Project Title:	Ballymastone LRD 3		
Document Title:	Ballymastone Phase 3 Parking Note		
Document Ref:	20003-DBF-XXXX-XX-RP-C01-000108	Rev:	4
Document Status:	P3-Planning : S-Issued

1. Introduction

This Technical Note provides an overview of the proposed car parking changes resulting from the amended planning application prepared in response to the Request for Further Information (RFI) from Fingal County Council in relation to the Ballymastone Phase 3 residential development. This Technical Note summarises the car parking provision as presented in the existing planning application and details how this provision has changed as a result of proposed amendments in response to the RFI.

Figure 1-1: BA09 Car Parking Spaces

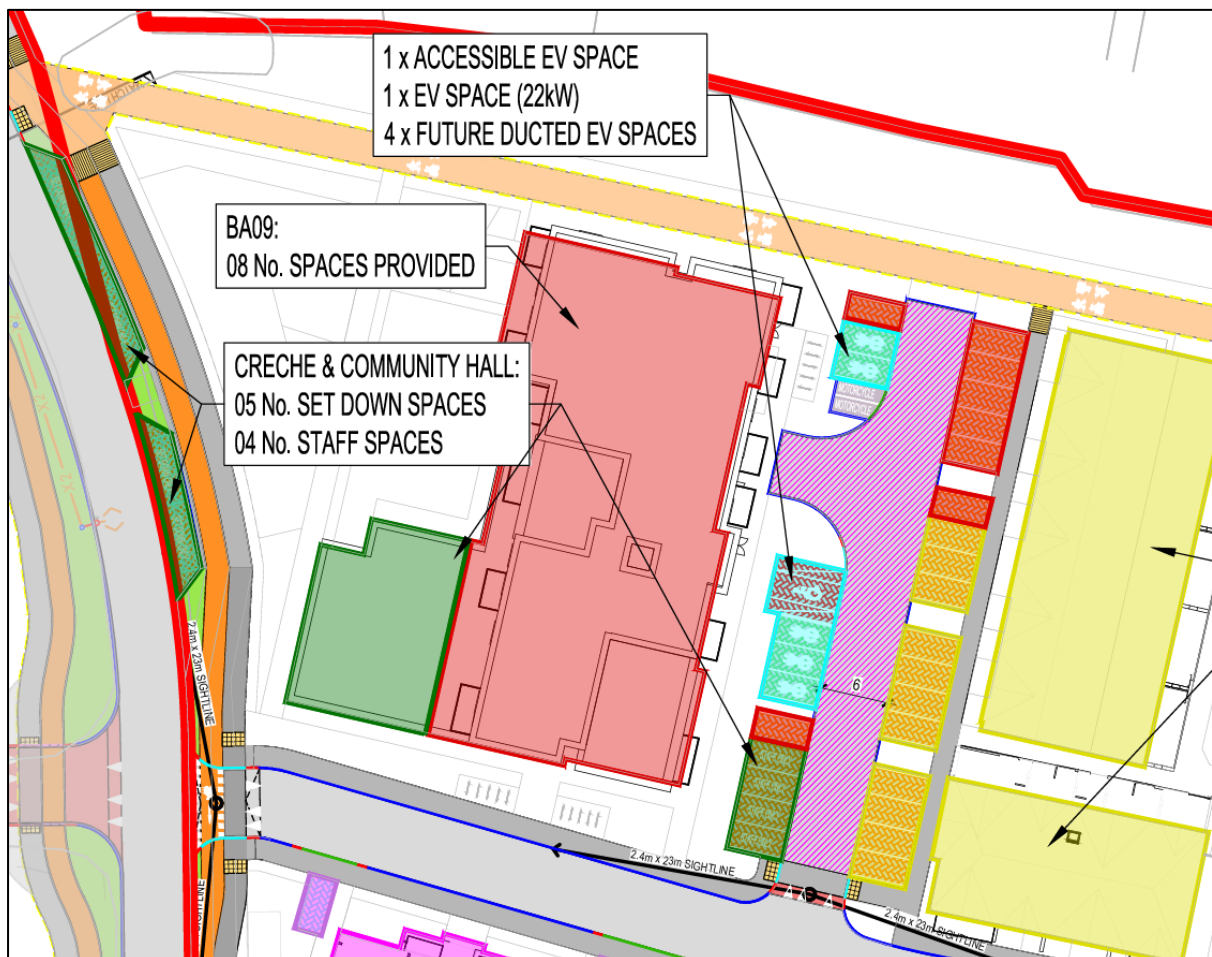
1 no. creche/community hall car parking space will be reassigned to BA09. There will be 1 no. additional car parking space provided which will be assigned to BA09, bringing the total number of spaces assigned to BA09 to 8 no. spaces, as illustrated in **Figure 1-1**.

Figure 1-2: BA07 & BA08 Car Parking Spaces

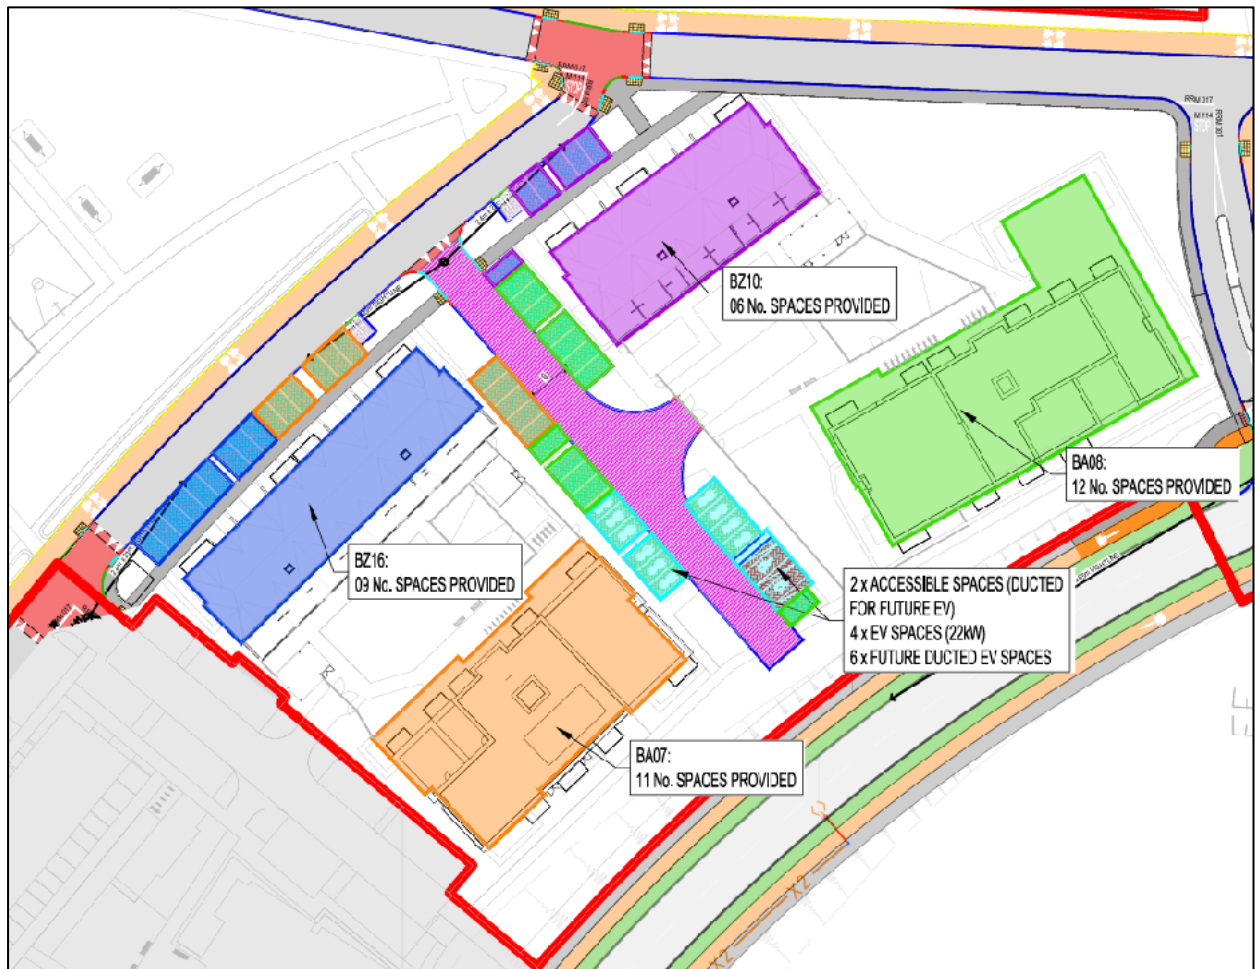
There will be 1 no. additional car parking space provided which will be assigned to BA08, bringing the total number of spaces assigned to BA08 to 12 no. spaces and BA07 to 11 no. spaces, as

illustrated in **Figure 1-2**. The 4 no. motorcycle spaces have been relocated from the end of the homezone to either side of the entrance to the homezone to enable the additional car parking space.
